# SUBDIVISION REPORT - CONCEPT/DEVELOPMENT PLAN

► **FILE #:** 12-SF-23-C **AGENDA ITEM #:** 37  
12-G-23-DP **AGENDA DATE:** 3/13/2025

► **SUBDIVISION:** LANTERN PARK  
► **APPLICANT/DEVELOPER:** S&E PROPERTIES, LLC  
OWNER(S): S&E Properties LLC

**CONCEPT PLAN OF LANTERN PARK SUBDIVISION**  
 12041 HARDIN VALLEY ROAD (PARCEL 116 06704)  
 KNOXVILLE, TN 37952

**CP3**  
CONCEPT PLAN  
10/30/2023

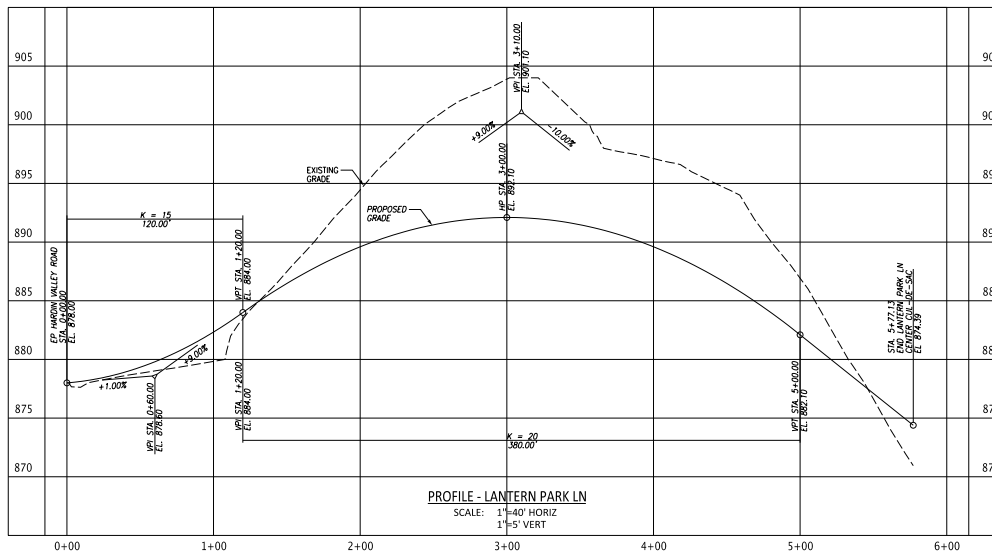
Vertical curve (crest) minimum K value for Road A from 25 to 20

Engineering Comments: Approve the variance based upon the justification provided by the applicant.

Vertical curve (sag) minimum K for Road A and Hardin Valley Rd intersection value from 25 to 15.

Engineering Comments: Approve the variance based upon the justification provided by the applicant.

Minimum distance between Mission Hill Lane and Road A from 400 feet to 368 feet

Engineering supports the variance requested (to be completed during review process): YES ☐ NO ☒

Engineering Comments: See attached.

Knox County Engineering and Public Works have routinely supported similar variances for many years, including ones on this roadway network, and specifically twice for this site but after review of Chancellor Weaver's findings in **Massey Creek Home Owners Association vs Knoxville-Knox County Planning Commission** and careful review of the minimum subdivision regulations requirements for granting a variance our staff does not believe adequate justification was provided to show a extraordinary hardship exists.
